## **M1 PACIFIC MOTORWAY EXTENSION TO RAYMOND TERRACE (SSI-7319)**

I refer to your email dated 28 July 2021 advising City of Newcastle ('CN') of a State significant infrastructure development (SSI-7319) submitted by Transport for NSW (TfNSW) for the above project and seeking CN's comments.

The submitted Environmental Impact Statement (EIS) has been reviewed and the following advice is offered for your consideration:

## 6 CN land Black Hill Interchange

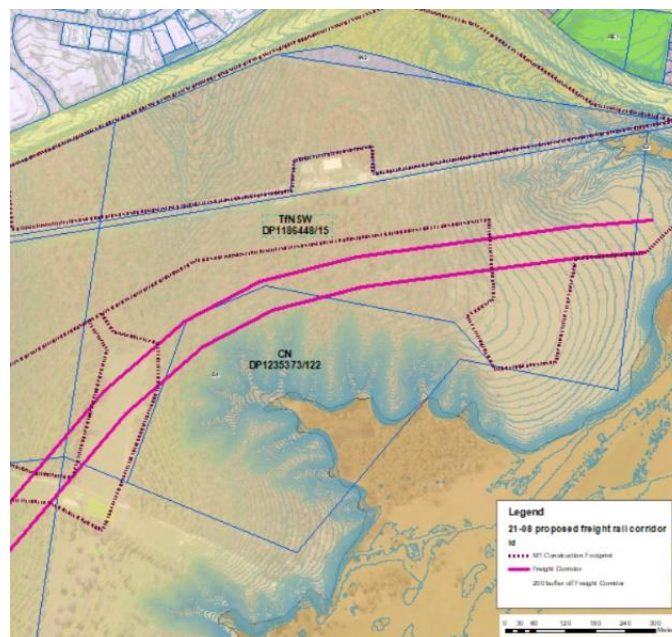
CN's land (DP1235373 /122) at the Black Hill Interchange is identified on the diagram below.

The EIS does not specifically discuss the small Coastal SEPP Wetland and high potential groundwater dependent ecosystem on this lot. It is noted proposed drainage concepts do not discharge onto this lot and this is appreciated.

As shown on the above diagram, the proposed heavy rail freight corridor (pink lines) runs around the ridge approximately 120m uphill of the Coastal SEPP Wetland and occupies approximately 1.5ha of the CN land parcel.

It is recommended this section of the proposed freight corridor, including all construction batters, is completely relocated out of CN land. This is raised now as it is understood that it requires consideration of vertical alignment and other matters for both projects. Consideration should be given to co-locating the freight rail within the excavated corridor of the M1 project. This may also offer visual amenity and noise mitigation benefits to Black Hill residents from the construction and operation of the freight line.

- There are no changes to the catchment and hydrology of the wetland area contained in this lot.
- No point discharge of stormwater from the M1 extension project into the lot (DP1235373 /122) for both operational and construction phases.
- Any proposed/upgrades to drainage easements as part of this project make provision for future drainage needs (construction and operation) of the freight corridor.
